HOPE PHYSICAL THERAPY-PARKING LOT

CONSTRUCTION DOCUMENTS

PPR-23-235

v3_Site Development Plan.pdf Markup Summary

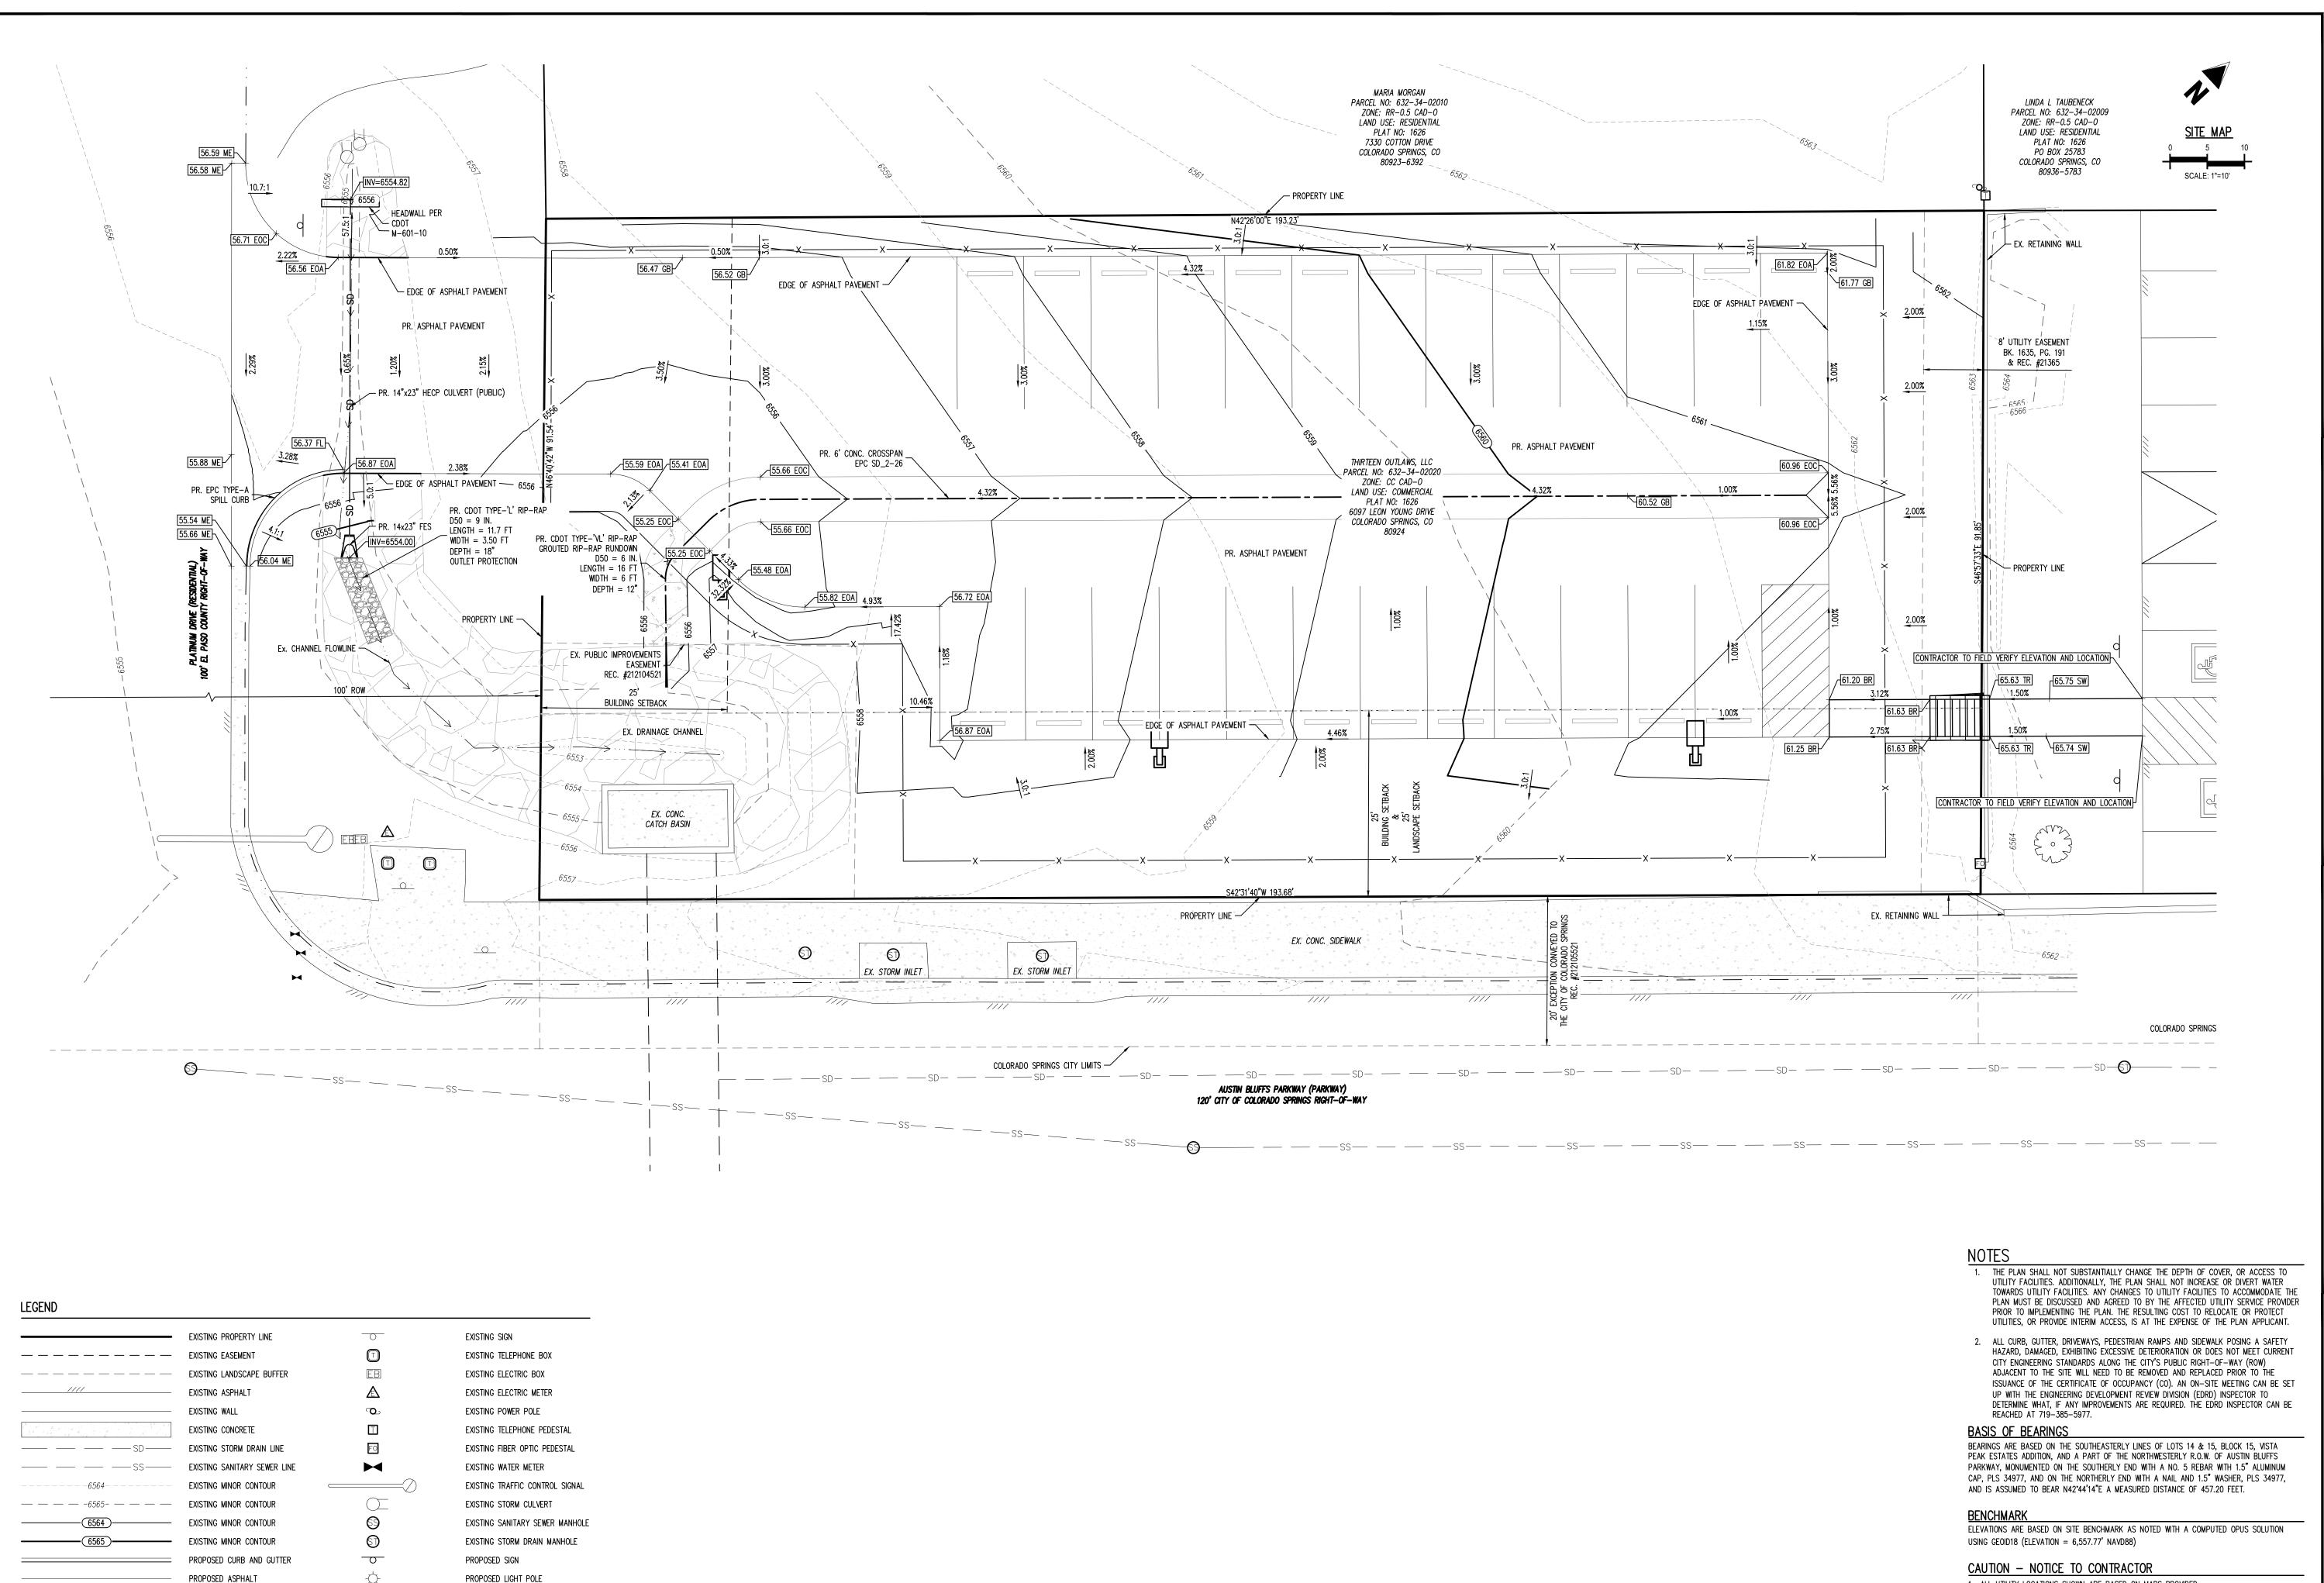
Status: Color: Layer: Space: Label what this hatching represents. Provide a

detail if needed.

Status: Color: Layer: Space: I misspoke on my previous comment and even though in public row, driveway culverts are still considered private. Please revise label to private

and the FAE will not be needed.
